## STAFF REPORT SUMMARY

To: Edgerton Planning Commission  
Fr: Kenneth Cook, AICP, CFM, Community Development Director  
Re: FP2017-01 for Final Plat for Inland Port XL, located West of Waverly Road and South of 181<sup>st</sup> Street.

To: Edgerton Planning Commission  
Fr: Kenneth Cook, AICP, CFM, Community Development Director  
Re: FP2017-01 Final Plat for Logistics Park Kansas City Rail Served-First Plat

To: Edgerton Planning Commission  
 Fr: Kenneth Cook, AICP, CFM, Community Development Director  
 Re: Application FS2017-01 for Final Site Plan for Inland Port XXI, located South of 191<sup>st</sup> Street and East of Four Corners Road.

Shrub List South Building End Only

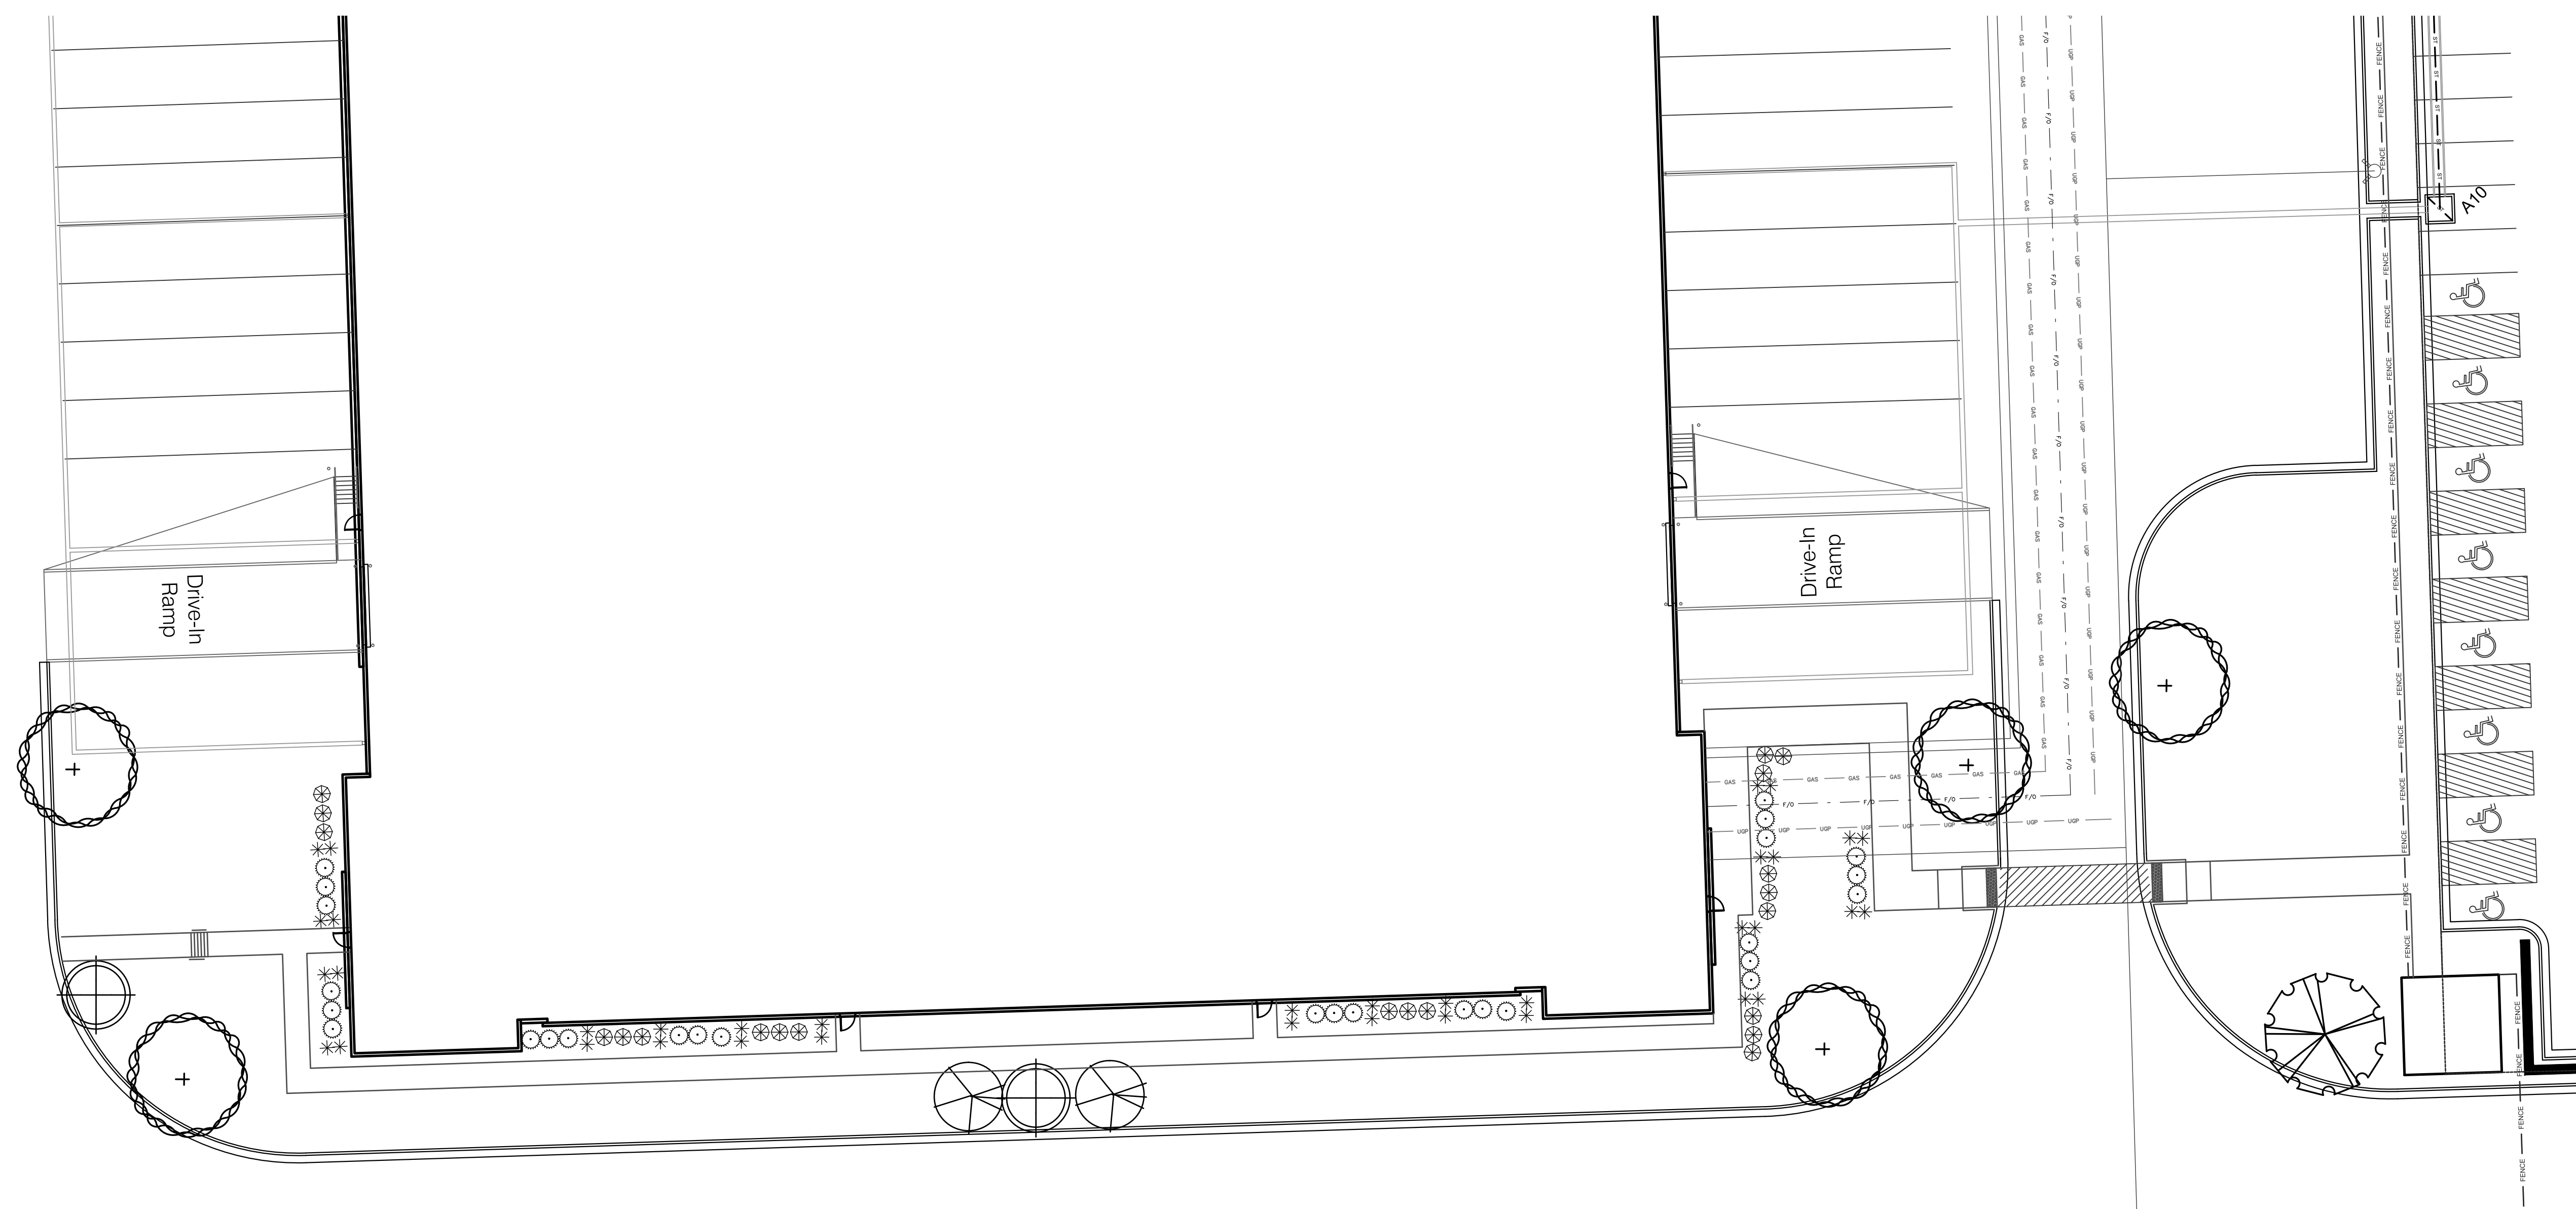
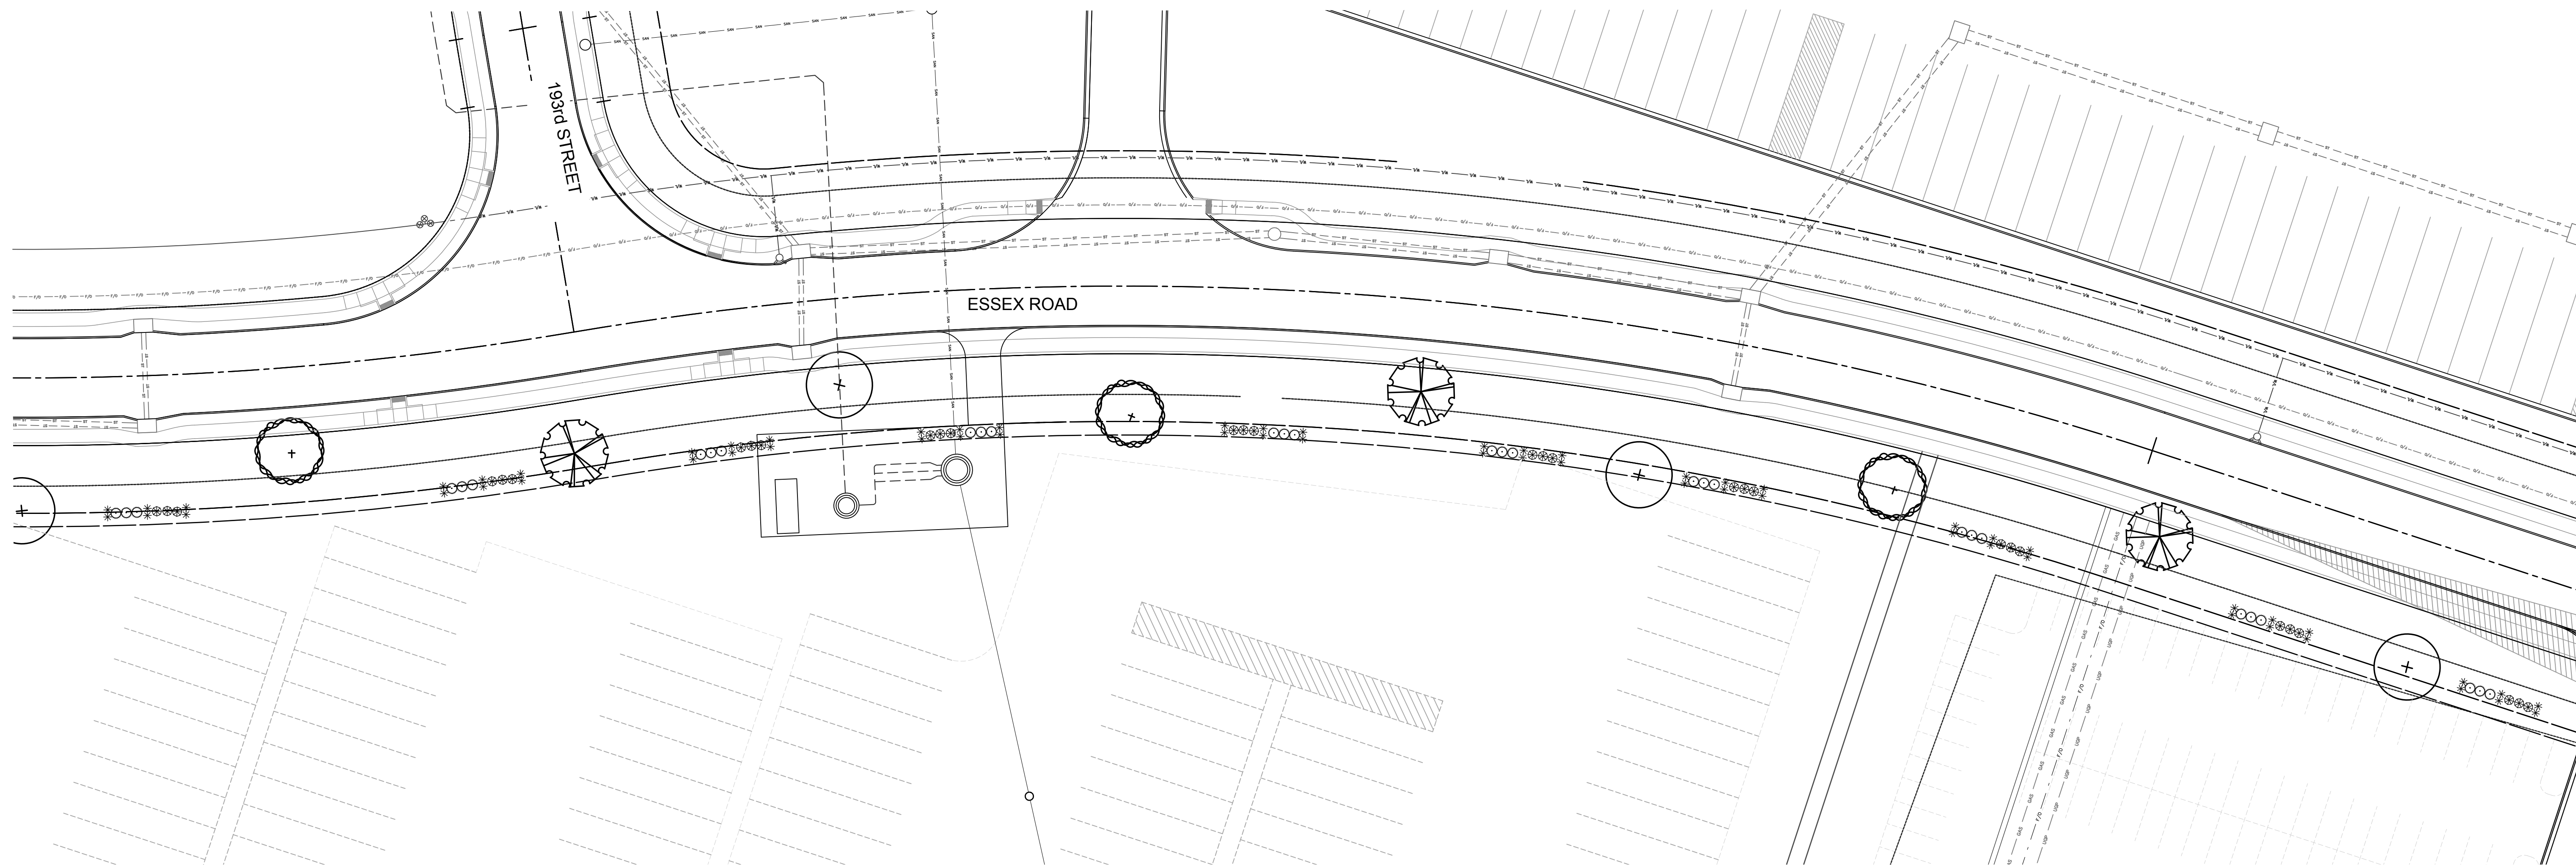
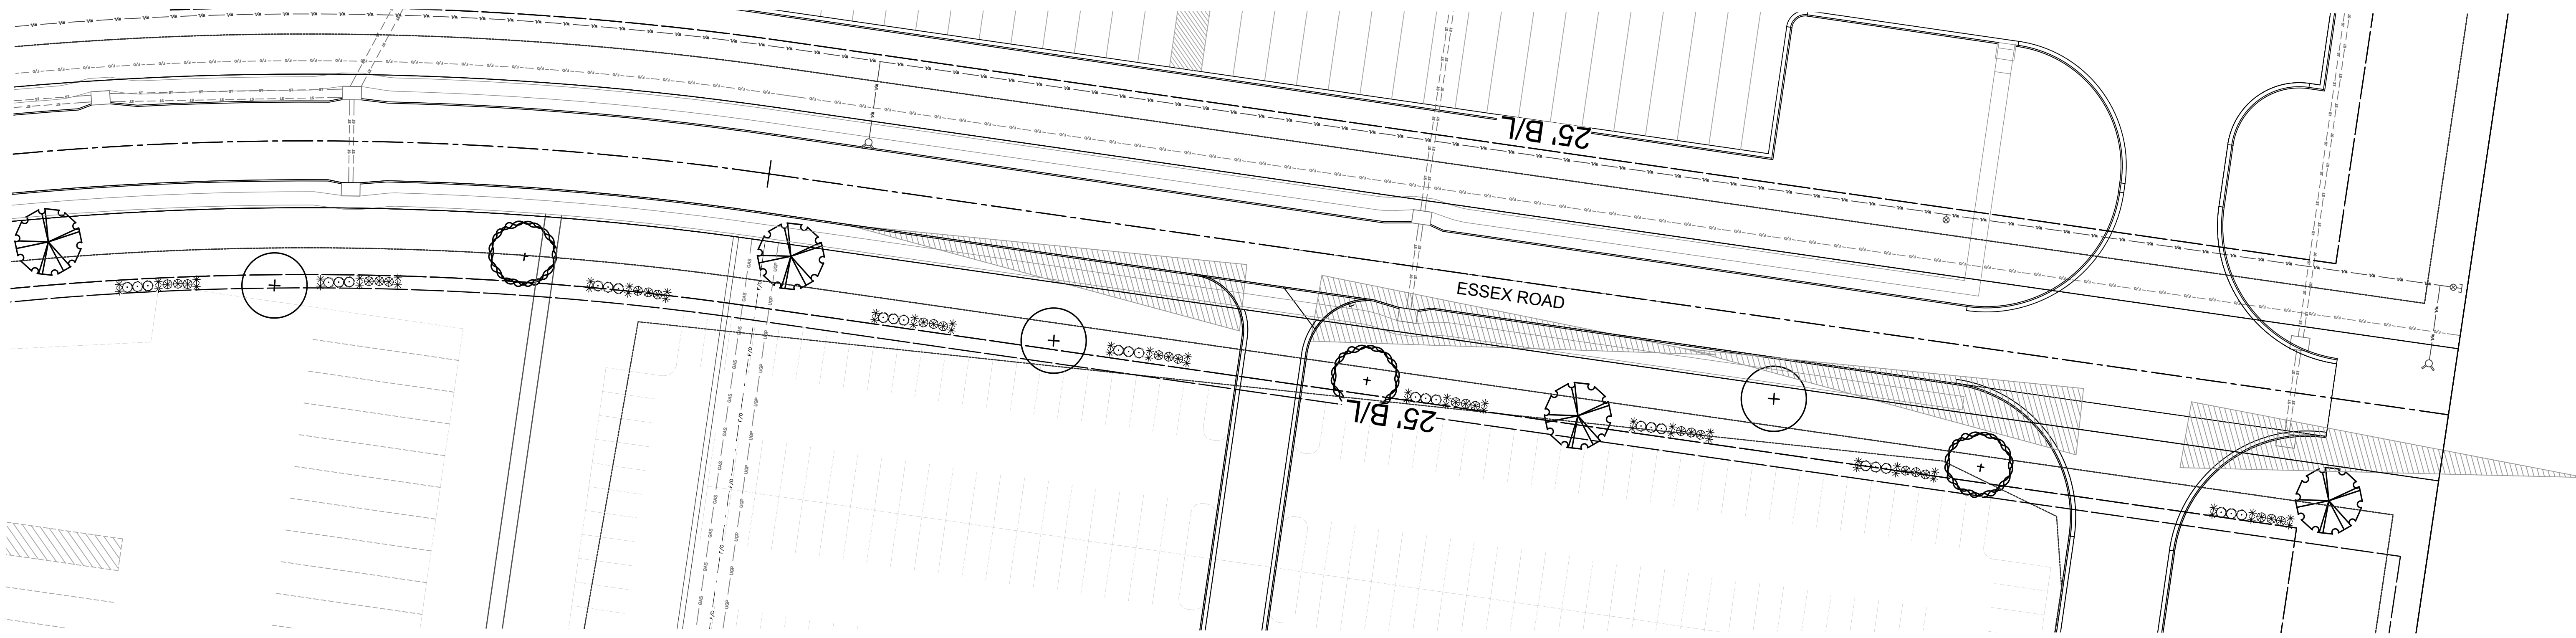
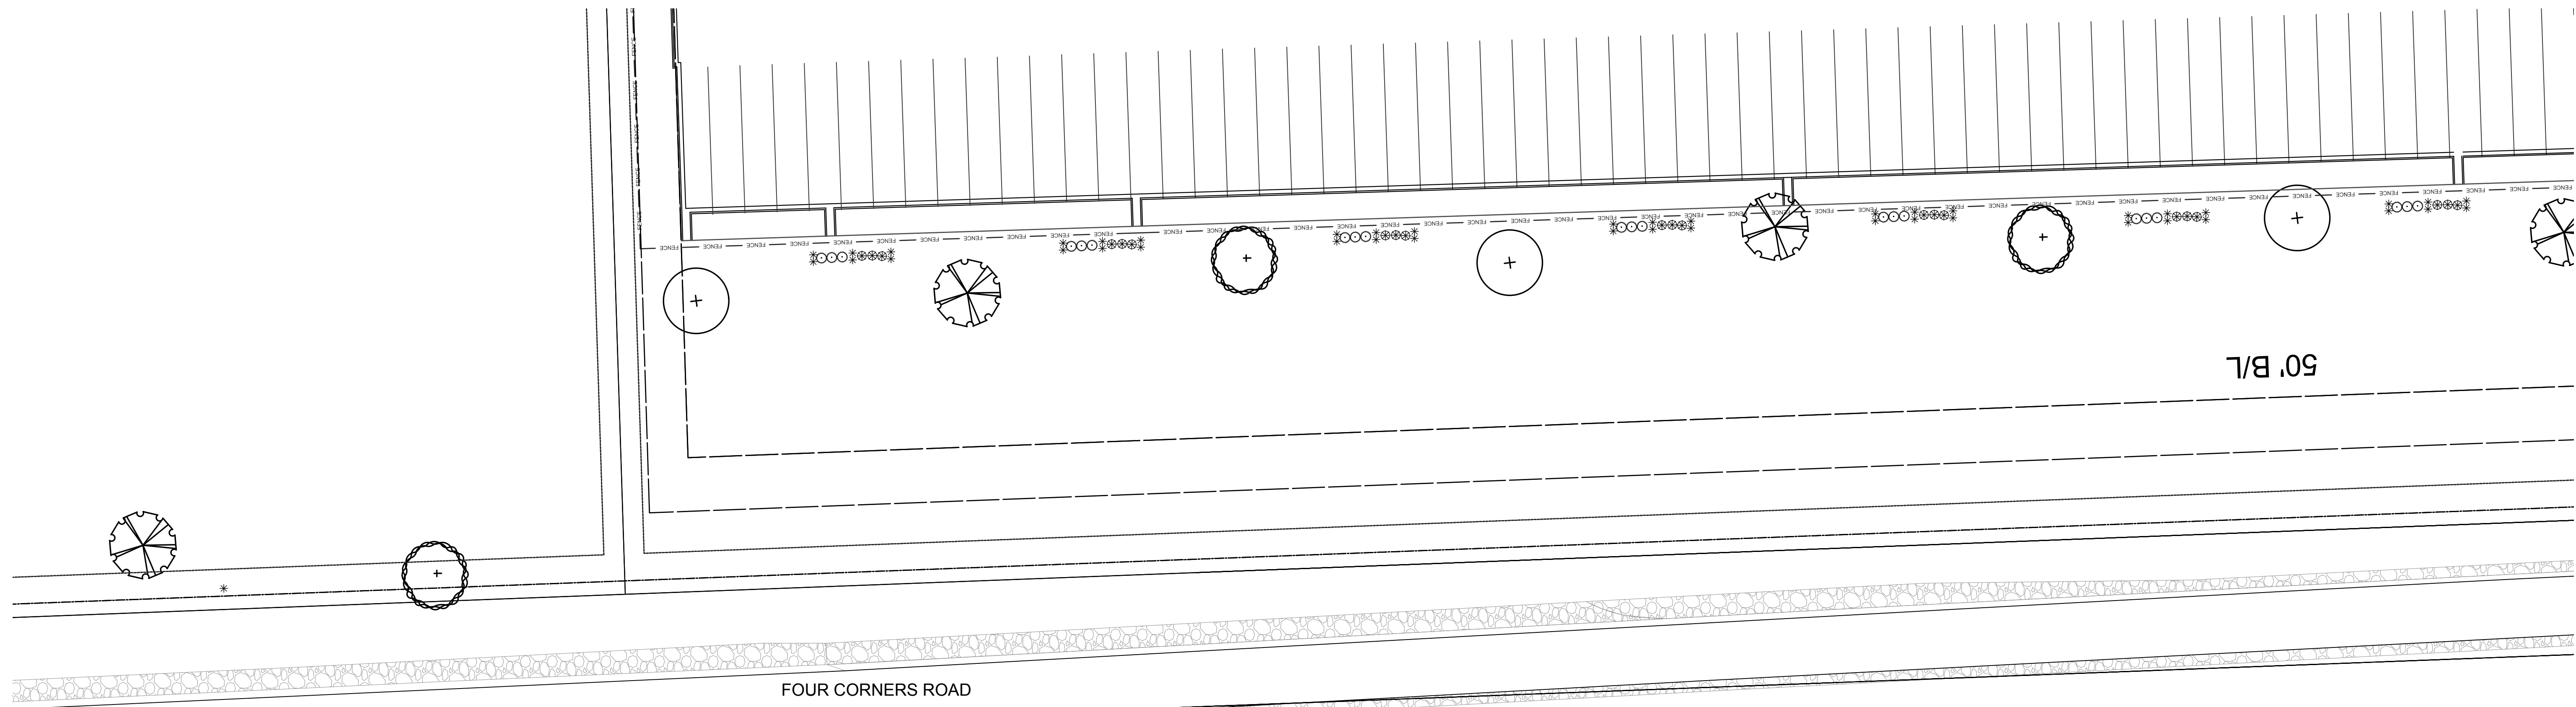
- *Trash containers and screening have not been shown.*
    - *Please indicate right-of-way for 191st Street on landscape plan sheets.*
    - *Very few shrubs, landscaping in parking areas or adjacent to the building have been provided.*

- *To the landscaping notes, please add text that states the proposed landscaping shall be installed so that when at full maturity it will not encroach into identified sight triangles.*

- *No timetable has been indicated for any of the planting.*
    - *Please verify quantities on both landscaping plans as the quantities listed for shrubs do not match those depicted and are generally substantially less than the quantities listed.*
